H11048

DESCRIPTIVE REPORT

Type of Survey HYDROGRAPHIC
Field No. RA-10-10-01
Registry No. H-11048

Descriptive Report to Accompany Hydrographic Survey H11048

Figure 3. H11048 Junction Surveys

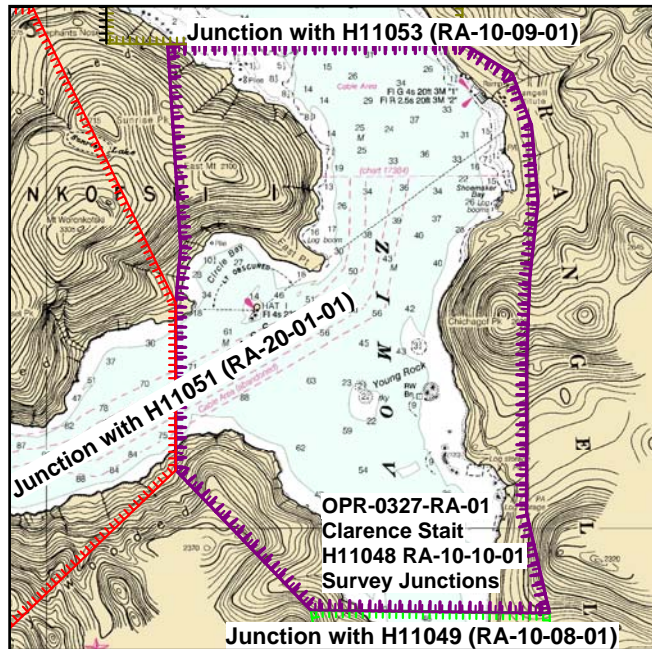
Survey H10951 junctions well with this survey, with differences less than one fathom. One exception is at 56°21'04.392"N, 132°27'09.721"W (657,405.7E, 6,248,084.1N), where H10951 shows a 72-fathom sounding near an 85-fathom sounding from H11048. This is on a very steep slope and the difference is likely due to large changes in depth over small horizontal distances on this slope.⁷

Survey H11049 junctions well with this survey, with differences of one fathom or less.⁸

At the time of this report, data processing for survey H11053 was not completed. Comparisons of the junction with this survey will be discussed in the Descriptive Report for H11053.⁹

⁷ Concur, the junction between survey H11048 and H10951 was not formally completed since survey H10951 was processed previously. Soundings and depth curves are in good agreement within the common area. An "Adjoins" note is shown on the smooth sheet in the junction area.

⁸ Concur, the junction between survey H11048 and H11049 was not formally completed since survey H11049 was processed previously. Soundings and depth curves are in good agreement within the common area. An "Adjoins" note is shown on the smooth sheet in the junction area.

⁹ The junction between survey H11048 and H11053 was completed during office processing. Soundings and depth curves are in good agreement within the common area. A "Joins" note is shown on the smooth sheet in the junction area.

Figure 4. New wreck in HDCS subset mode

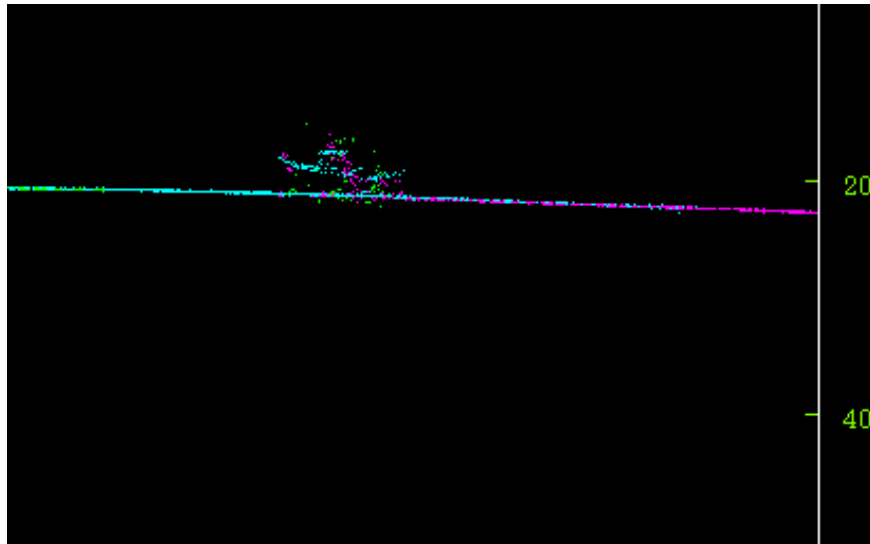
A new wreck was located at 56°24'31.071"N, 132°24'10.423"W (660241.270 E, 6254586.675 N) with a least depth of 8.2 fathoms (see figure 4). The least depth was obtained with SWMB. The Hydrographer recommends charting a wreck of known depth in this position.³³

³³ Concur

Figure 5. New wreck in HDCS line mode

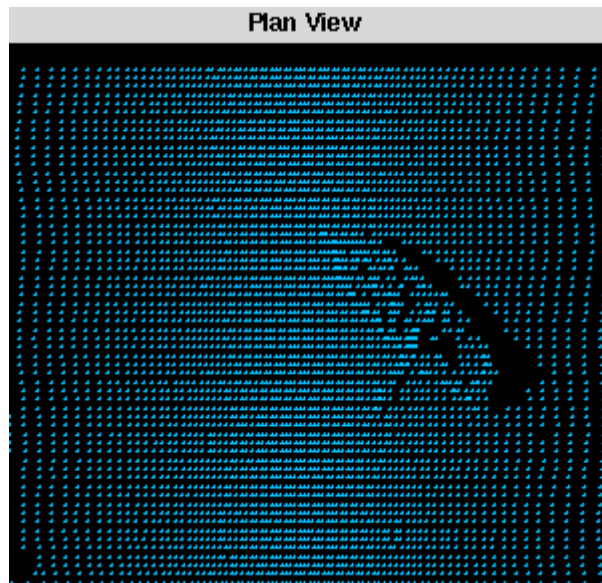
A new wreck was located at 56°20'00.720 N, 132°20'52.703" W (663744.400 E, 6255151.607 N) with a least depth on the mast of 2.7 fathoms (see figure 5). The least depth was obtained with SWMB. The Hydrographer recommends charting a wreck of known depth in this position.³⁵

³⁵ Concur

OPR-0327-RA-01
NORTHERN CLARENCE STRAIT
H11048_SHEET K

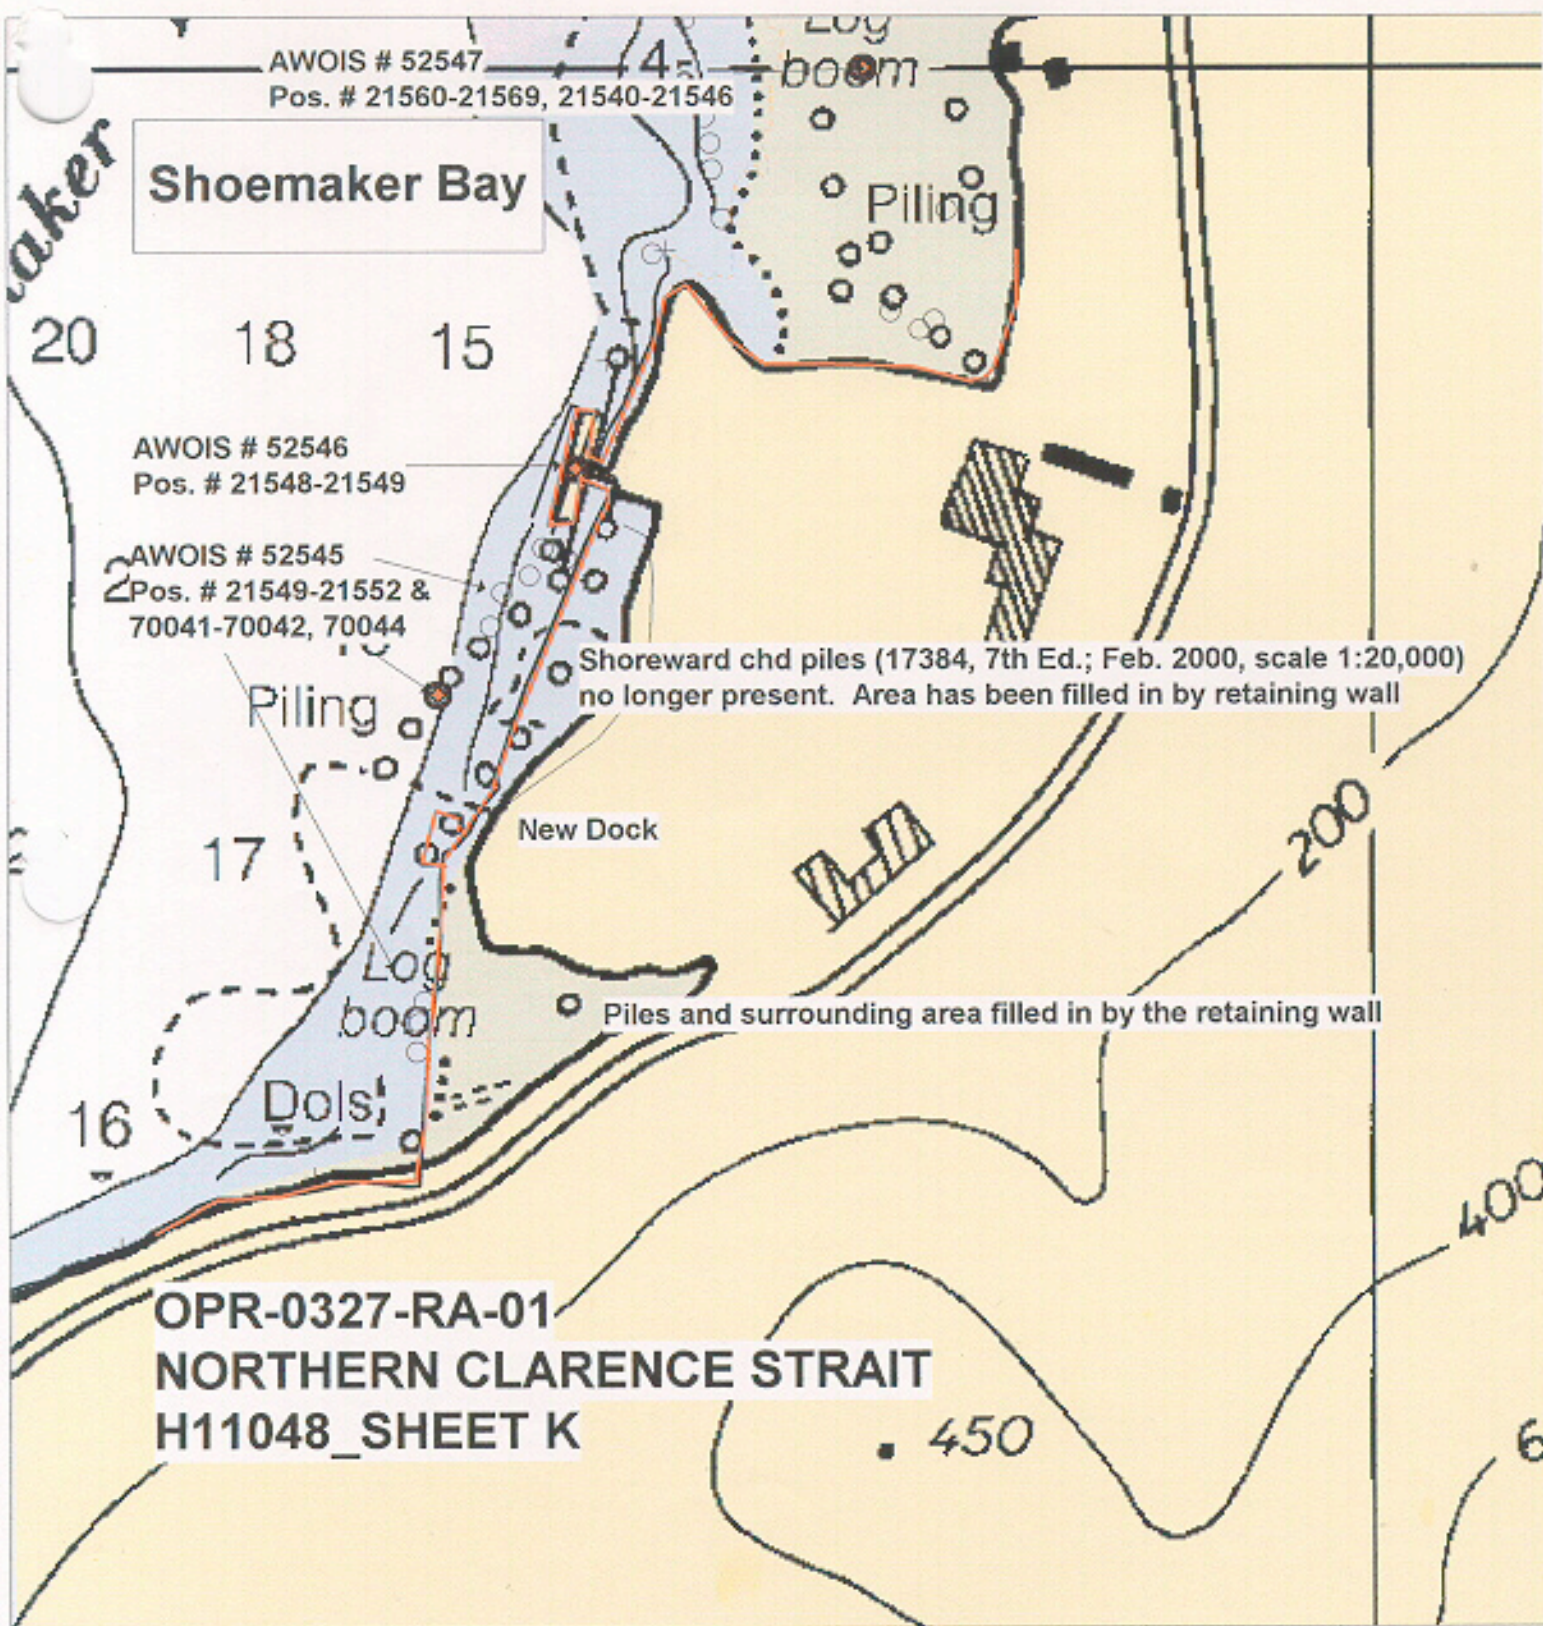
Fieldnote INVESTIGATION
 DATE(S):04 /25/01 (DN: 119)
 HYDROGRAPHIC SURVEY NUMBER:H11048
 VN: 2122 TIME: See Below
 INVESTIGATION METHODS USED: (IE DI, 200% SIDE SCAN SONAR, ECHO SOUNDER) VBES, SWMB and Visual
 SURVEYED POSITION: See Below
 POSITION DETERMINED BY: DIFFERENTIAL GPS
 INVESTIGATION SUMMARY: A visual search was conducted for the piles and logbooms. The piles were positioned at HW on a gravel beach which exposes at MLLW.
 CHARTING RECOMMENDATION (HYDROGRAPHER): Remove charted (17384) piles and chart piles at the follwing positions:

Thirteen piles in a row were not positioned between 56-23-53.46 N, 132-20-19.81 W and 56-24-01.59 N, 132-20-23.37 W due to inaccessibility created by the logboom or shoal nature of the area. The Hydrographer recommends charting a row of piles with a dashed-line notation, with the following extents:

Chart isolated piles at the following positions:

Chart six new dolphins at the following positions:

Chart a new marine rail way at the following position:

EVALUATOR COMMENTS: Concur
